DRESDEN STATION SPECIAL REPORT NO. 28

General Electric IF-300 Spent Fuel Shipping Cask

ADDENDUM 2

Report of Discussions with AEC Staff

FIGURE 2

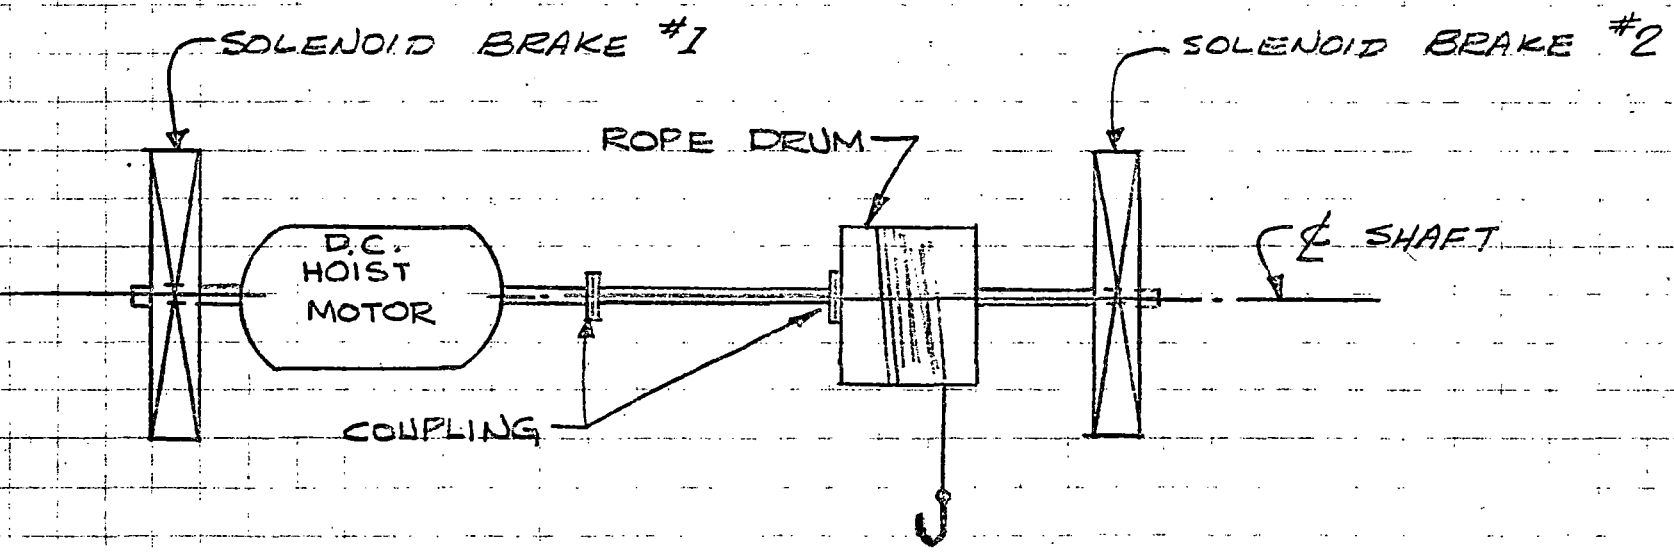
The shoe brakes are located at the inboard and outboard ends of the main hoist drive shaft as shown in simplified sketch, Figure 2. The dynamic brakes are an integral part of the motor and cannot be seen. Any one of the two shoe brakes is capable of stopping the hoist under full load. The dynamic brake is not capable of bringing the load to a "dead stop," it can only control the rate of descent.

SARGENT & LUNDY FOR COMMONWEALTH EDISON CO.
 MAIN HOOK ON CRANE NO. 9492 (REQ. 78065)
 125 TON CAPACITY SISTER HOOK - 6" EYE

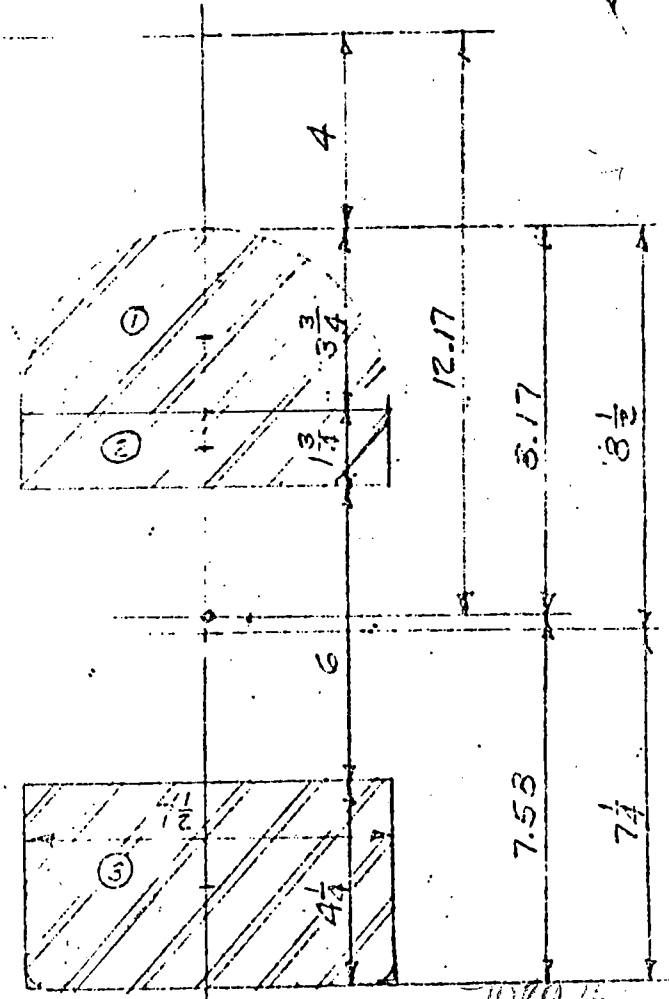
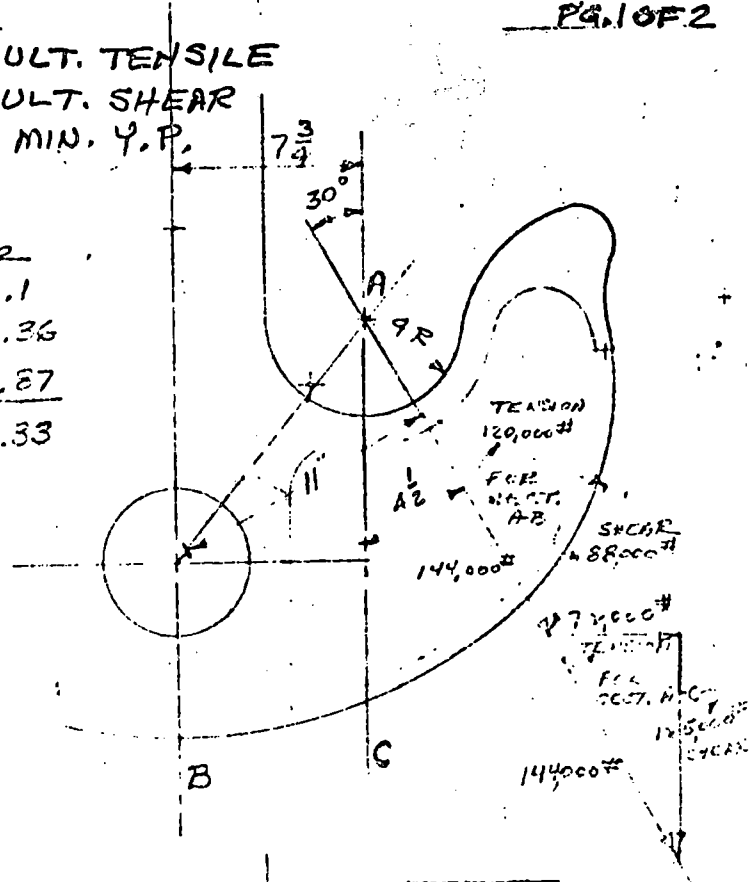
Stress calculations on the existing 6" I.D. hook show that the tensile stress is 10,250 psi with a safety factor of 6.83 based on minimum average tensile strength. Stress calculations were made on the basis of machining the hook to a 6 1/16" I.D. The resulting tensile stress is 10,280 psi and the safety factor is 6.81 (see Figure 7). Specification EOCI #61 states no minimum safety factor for a hook.

SAFETY FACTOR = $\frac{70,000}{10,250} = 6.83$
